Macquarie University Arts Precinct

*State Significant
Development
Modification Assessment
(SSD 8388 MOD 1)*

September 2018

Figure 5 | Comparison of Approved (top) and Proposed (bottom) 25WWC Roof Terrace

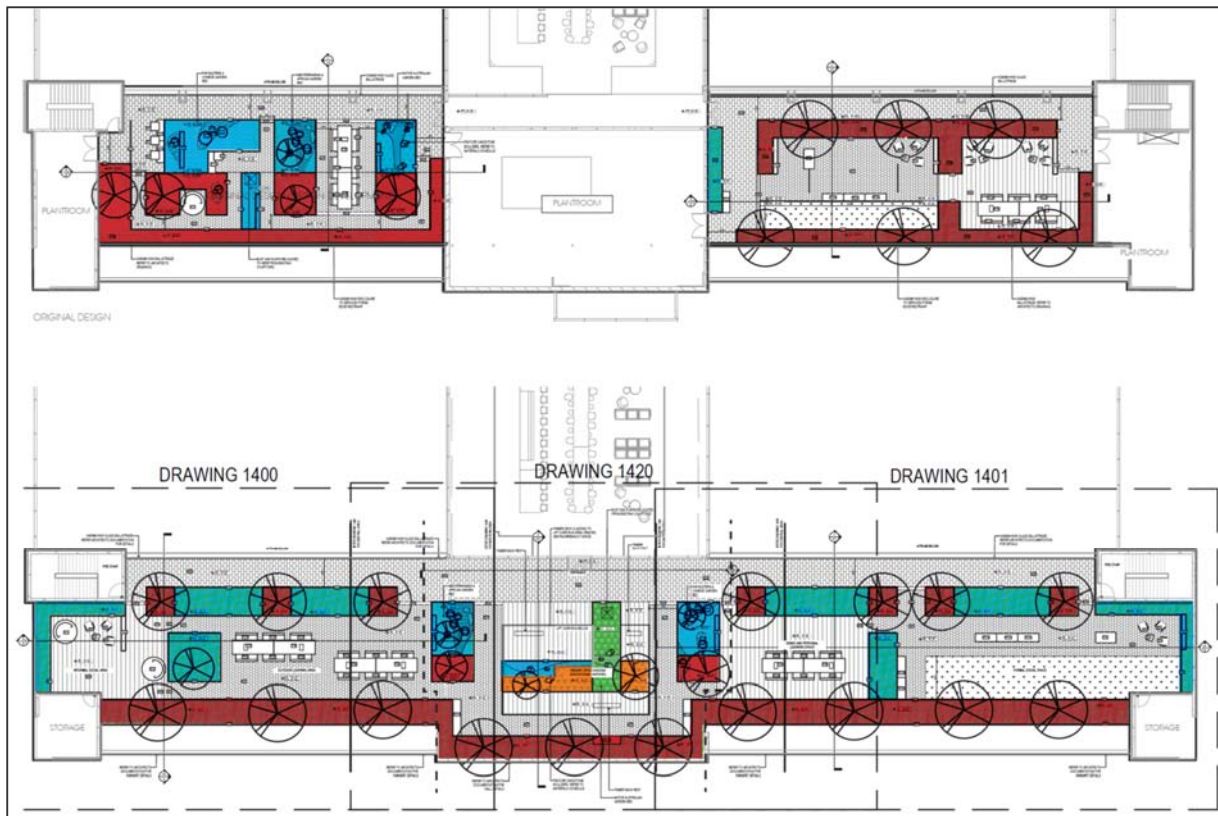
The roof terraces of 25WWC are proposed to be extended into the areas previously occupied by cooling towers, resulting in a 52 per cent increase in the usable outdoor recreation area. Further, the walls which previously surrounded the cooling towers will be deleted, creating a more inviting amenity on the terrace (see **Figure 5**).

The Department referred the proposal to the Government Architect NSW (GANSW) for review. The GANSW was fully supportive of the proposed consolidation and reducing of plant and mechanical servicing for the approved development. The GANSW is satisfied that the proposed changes to building design are minor and do not compromise the integrity of the original endorsed design.

The Department is satisfied that the modifications will not result in any additional adverse environmental or amenity impacts. Conversely, the amenity offered to users of the approved buildings will improve in quality due to the increase in roof terrace area on 25WWC. A number of new study spaces for students will also be made available with the buildings.
